## APPLICATION BY AQUIND LIMITED

### DEADLINE 8: WRITTEN STATEMENT ON BEHALF OF THE UNIVERSITY OF PORTSMOUTH

1<sup>ST</sup> MARCH 2021

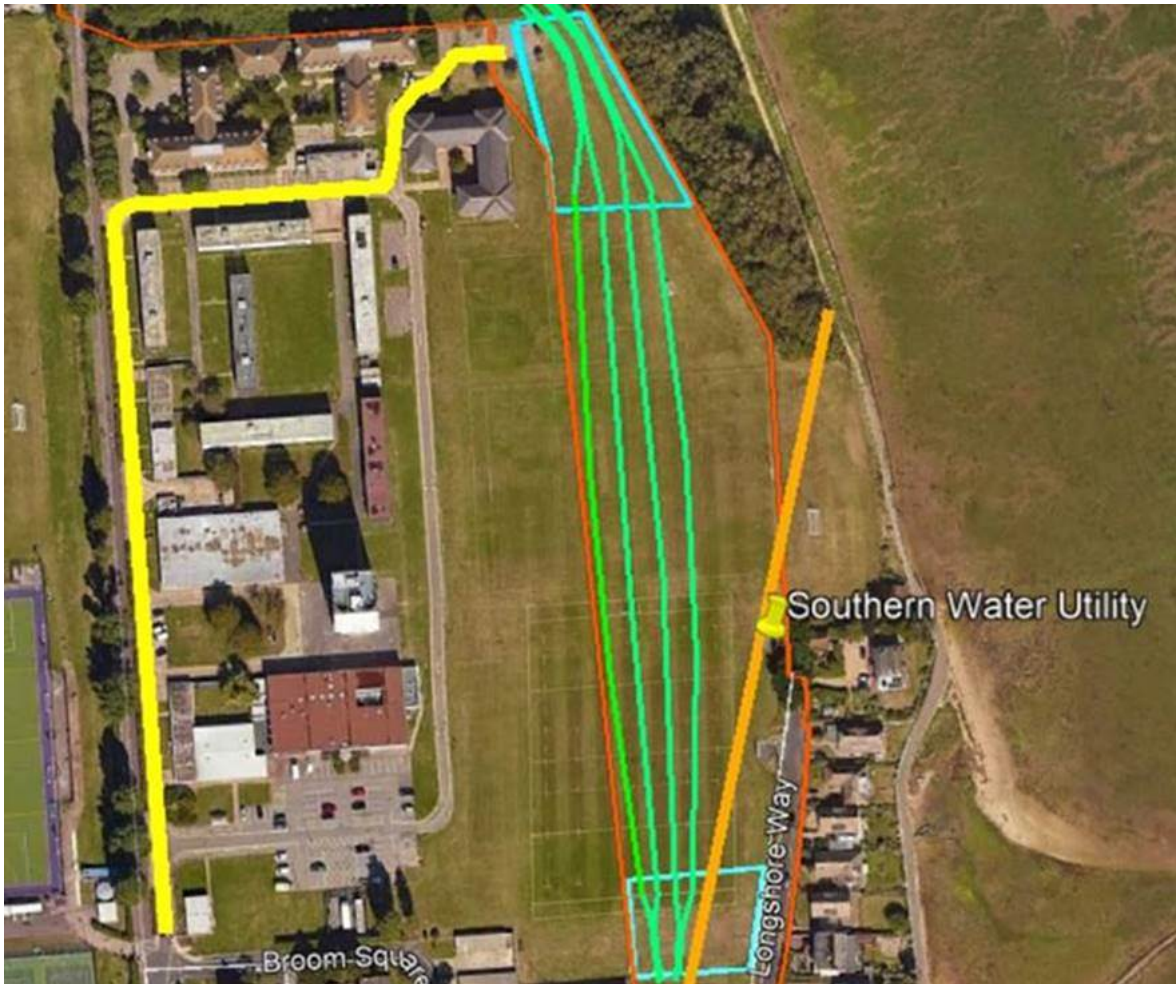
- **HDD –v– Open Trenching:** as identified during the meeting and in our OFH1 submission, it has not been demonstrated to the satisfaction of the University that HDD will be less disruptive than open trenching. Whilst we noted the installation technique, the need for compound sites at either end and the fact that the works might take longer, it still appears to us that the overall impact on the sports pitches could be considerably less if HDD was undertaken. Please can you provide us with a full explanation as to why HDD has not been considered in this area? Our position on open trenching is clear and given the advantages that HDD potentially has in terms of disruption across the site and the associated impacts, we would welcome confirmation from you on the exact size and position of the compounds and the programme impact. We can then compare that to the impacts identified in our submissions to date and report back to you and the Examining Authority.

**HDD has not been considered in detail in this area because it is not necessary. HDD is not without implementation risks and the standard approach to cable installation on the Aquind project and projects like Aquind is to avoid HDD unless its implementation is absolutely necessitated by technical or environmental factors. Notwithstanding this, to aid visualisation, I have provided an indicative layout for a HDD as shown below. The presence and location of the Southern Water Pipeline results in the HDD taking place from west of the pipeline to remove any risk of the HDD encountering it or impacts on the cables if Southern Water were to carry out work in this area again in the future. The southern and northern compounds are shown by the blue outlines and the access route for construction traffic to the northern compound is shown in yellow. Each of the 4 no. bores (one for each HVDC cable) is shown in green.**

**It should be noted that the Easement for the HDD, as shown below, would cover an area of approximately 8600m<sup>2</sup> compared to approximately 3400m<sup>2</sup> for the open trenching installation (assuming 325m length x 10.4m easement width). There is also a potential that the easement for open trenching could be narrower depending on the specification of the cable manufacturer chosen and the installation depth of the cables, which in turn determines separation distances.**
